**Work Plan for a  
Treatability Study in Support of the  
Intrinsic Remediation (Natural Attenuation) Option at  
Pumphouse 5 (Building 771)**

**Griffiss Air Force Base  
Rome, New York**

Subject: Response to Comments on the "Intrinsic Remediation Treatability Study (TS) for Pumphouse 5", Griffiss AFB, New York.

**I. Response to comments submitted by Mr. Jonathan Greco, Bureau of Eastern Remedial Action, Division of Hazardous Waste Remediation, at the New York State Department of Environmental Conservation, received May 30, 1995.**

FIGURE 2.14

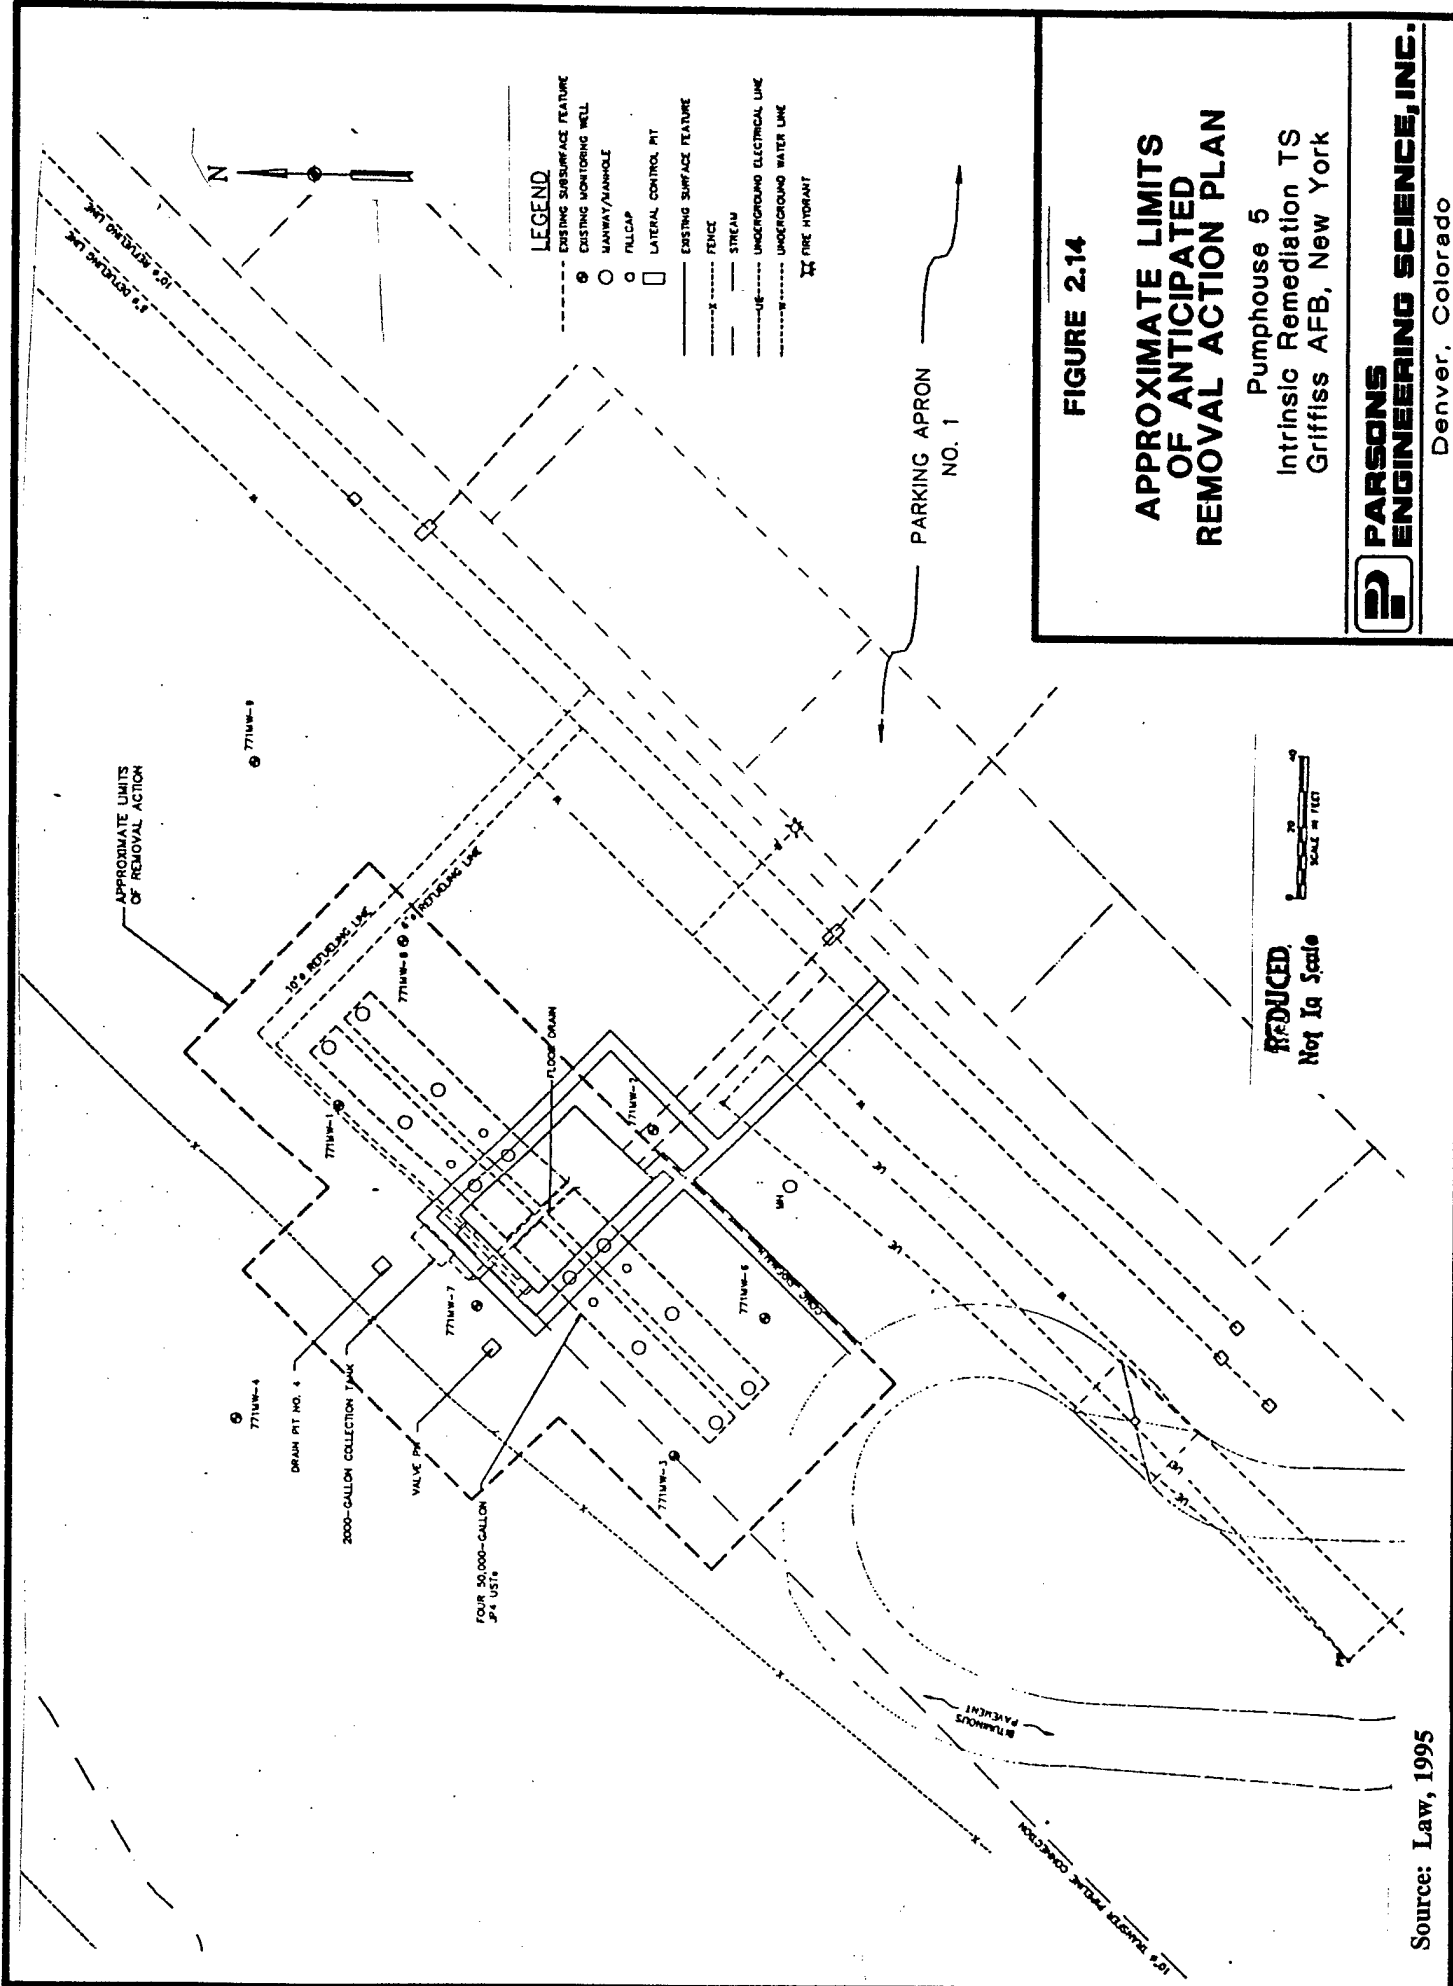
7. Please explain the use of the "valve pits." Also I would expect that piping would be connected to the valve pit; however, the diagrams (i.e., Figure 2-14) do not indicate that they are connected. Please clarify this issue.

**Response:** Agree, piping is connected to the valve pits; however, available diagrams used for this report do not indicate the location of piping connecting the USTs to the valve pits. Additional description on the use of valve pits has been included in the final paragraph on page 1-10 and reads (in bold):

"...response to precipitation or snowmelt filling the valve pit and clogging the valve system (Law, 1995). **The valve pits are used for isolation or diversion valves required for UST operation or for future expansion fuel storage operations.** Seasonally high groundwater elevations may also have pushed floating product from..."
